SEQUOYAH NUCLEAR PLANT UNITS 1 AND 2
DELAY OF REACTOR TRIP DUE TO ARCING ACROSS
UNDERFREQUENCY RELAY CONTACTS

NCR EEB 79-13
10 CFR 50.55(e)
FINAL REPORT

SEQUOYAH NUCLEAR PLANT
 UNDERFREQUENCY INPUTS TO THE
 SOLID STATE PROTECTION SYSTEM
 (MODIFICATIONS DUE TO NCR EEB 79-13)

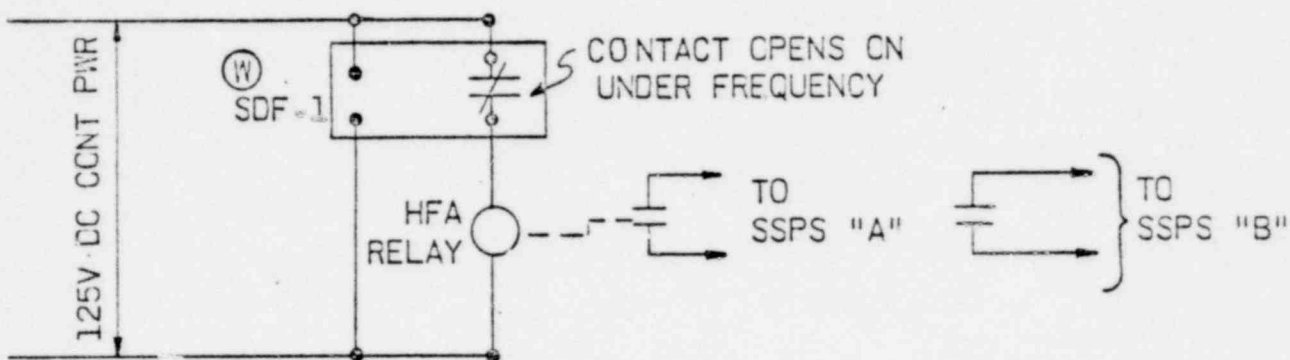
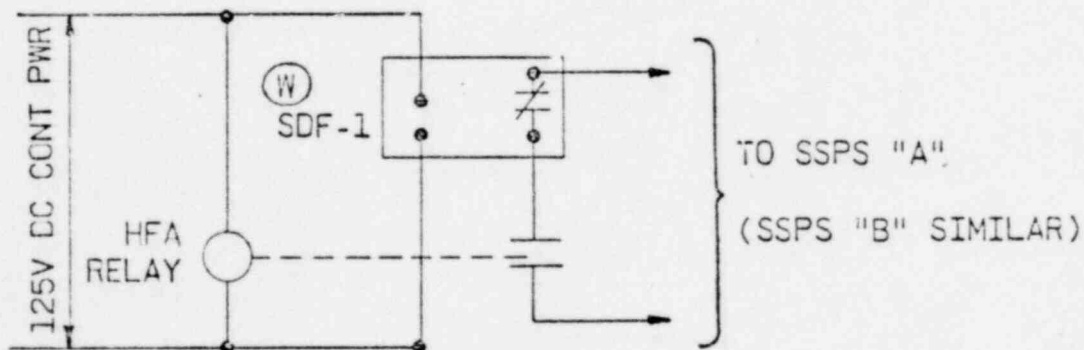
During the preoperational testing of the underfrequency inputs into the solid-state protection system, arcing occurred across the underfrequency relay contacts. The problem involves the underfrequency and auxiliary relays on the reactor coolant pump underfrequency and undervoltage protection panels. This arcing caused the auxiliary relay to chatter and delay the reactor trip and the reactor coolant pump breaker trip signals. There are two auxiliary relays associated with each reactor coolant pump.

The SDF-1 relay (see attached figure) senses the frequency by a solid state circuit which energizes a telephone type relay on underfrequency. Arcing occurs when the telephone relay contacts deenergize a large inductive load. The solid state circuits are adversely affected by noise generated by the arcing. This then causes the telephone relay to chatter which delays the trip signal to the SSPS.

The relay panel will have the SDF-1 relays modified internally so that there will be two normally closed contacts available for external connections (presently there is available only one normally closed and one normally open contact for external connections). The two normally closed contacts will be used to deenergize a small 120-volt ac general purpose relay located in the SSPS cabinets. Testing has verified that the VF relay will be able to energize and deenergize the small general purpose relay in the SSPS without contact chatter. The auxiliary relay will be used to monitor control voltage and will send a trip signal to the SSPS by opening contacts in series with the VF relay contacts upon loss of control power.
